Access Compliance Report

Public Rights-of-Way

(Curb Ramps)

Intersection ID: N/A	Main Street: COLONEL FRANCIS J BEATTY PARK DR	Cross Street: PARKGATE DR	Location: SE
ADA ID: 7DD24FEF5ED4	Ramp Type: PerpDiag	Initial Pass/Fail: Fail	Overall Compliance: No
		Severity Score: 22.5

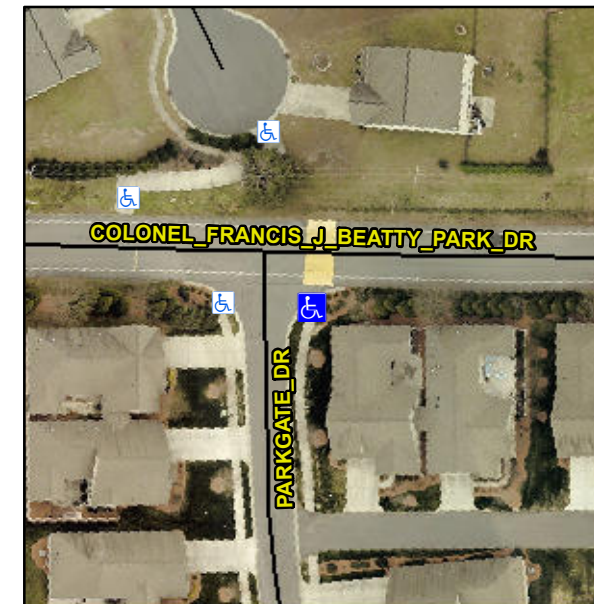
Not Found, R304.5.1, R304.2.2, R304.5.3

Compliance	Description	Data	Compliance	Description	Data
N/A	Ramp Length (in)	48.0	No	Ramp Slope (%)	8.4
No	Ramp Width (in)	40.0	No	Ramp XSlope (%)	4.8
N/A	Flare Type LT	N/A	N/A	Flare Type RT	N/A
N/A	Flare Slope LT (%)	N/A	N/A	Flare Slope RT (%)	N/A
N/A	Flare Traversable LT?	N/A	N/A	Flare Traversable RT?	N/A
N/A	Landing Length (in)	N/A	N/A	DWS Provided?	N/A
N/A	Landing Width (in)	N/A	N/A	DWS Contrast?	N/A
N/A	Landing Slope (%)	N/A	N/A	DWS Length (in)	N/A
N/A	Landing X Slope (%)	N/A	N/A	DWS Full Width?	N/A
N/A	Landing Curb? (Y/N)	N/A	N/A	DWS Offset (in)	N/A
N/A	Shared Landing?	N/A			
N/A	Gutter Ponding?	N/A	N/A	Gutter Slope (%)	N/A
N/A	Gutter Lip Ht (in)	N/A	N/A	Gutter X Slope (%)	N/A
N/A	Painted X Walk1?	No	N/A	Painted X Walk2?	No
	X Walk 1 Direction	To N		X Walk 2 Direction	To W
N/A	X Walk 1 Width (in)	N/A	N/A	X Walk 2 Width (in)	N/A
	X Walk 1 Slope (%)	7.0		X Walk 2 Slope (%)	0.3
	X Walk 1 X Slope (%)	1.4		X Walk 2 X Slope (%)	1.9

Remove & Replace Curb Ramp With Two New Directional Ramps or Equivalent.
